# Access Compliance Report

## Public Rights-of-Way

Intersection ID: 25491	Main Street: SOUTHBRIDGE_FOREST_DR	Cross Street: CANE_FIELD_DR	Location: NE
ADA ID: 50964BF11D03	Ramp Type: PerpDiag	Initial Pass/Fail: Fail	Overall Compliance: No
Severity Score: 12.5			
Codes/Mitigation Info/Possible Solution		Field Measurements/Component Compliance

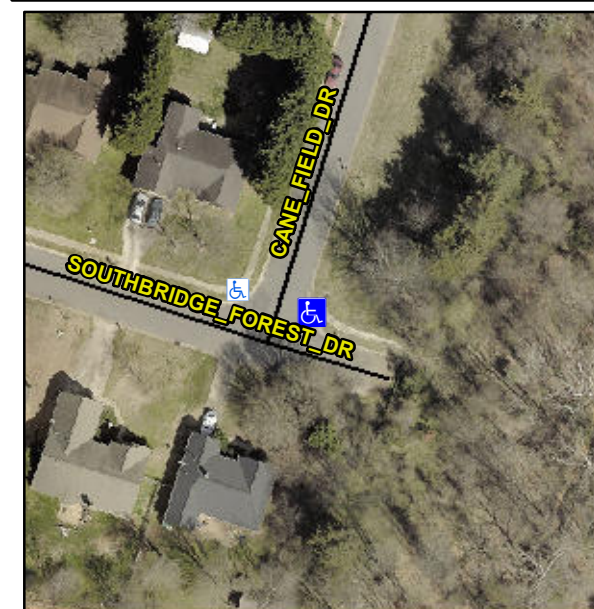
**Remove & Replace Curb Ramp With Two New Directional Ramps or Equivalent.**

**R304.2.2**

Compliance	Description	Data	Compliance	Description	Data
N/A	Ramp Length (in)	58.0	No	Ramp Slope (%)	9.5
Yes	Ramp Width (in)	48.0	Yes	Ramp XSlope (%)	0.4
N/A	Flare Type LT	N/A	N/A	Flare Type RT	N/A
N/A	Flare Slope LT (%)	N/A	N/A	Flare Slope RT (%)	N/A
N/A	Flare Traversable LT?	N/A	N/A	Flare Traversable RT?	N/A
N/A	Landing Length (in)	N/A	N/A	DWS Provided?	N/A
N/A	Landing Width (in)	N/A	N/A	DWS Contrast?	N/A
N/A	Landing Slope (%)	N/A	N/A	DWS Length (in)	N/A
N/A	Landing X Slope (%)	N/A	N/A	DWS Full Width?	N/A
N/A	Landing Curb? (Y/N)	N/A	N/A	DWS Offset (in)	N/A
N/A	Shared Landing?	N/A			
N/A	Gutter Ponding?	N/A	N/A	Gutter Slope (%)	N/A
N/A	Gutter Lip Ht (in)	N/A	N/A	Gutter X Slope (%)	N/A
N/A	Painted X Walk1?	No	N/A	Painted X Walk2?	No
	X Walk 1 Direction	To NW		X Walk 2 Direction	To SW
N/A	X Walk 1 Width (in)	N/A	N/A	X Walk 2 Width (in)	N/A
	X Walk 1 Slope (%)	4.9		X Walk 2 Slope (%)	3.5
	X Walk 1 X Slope (%)	0.1		X Walk 2 X Slope (%)	1.1
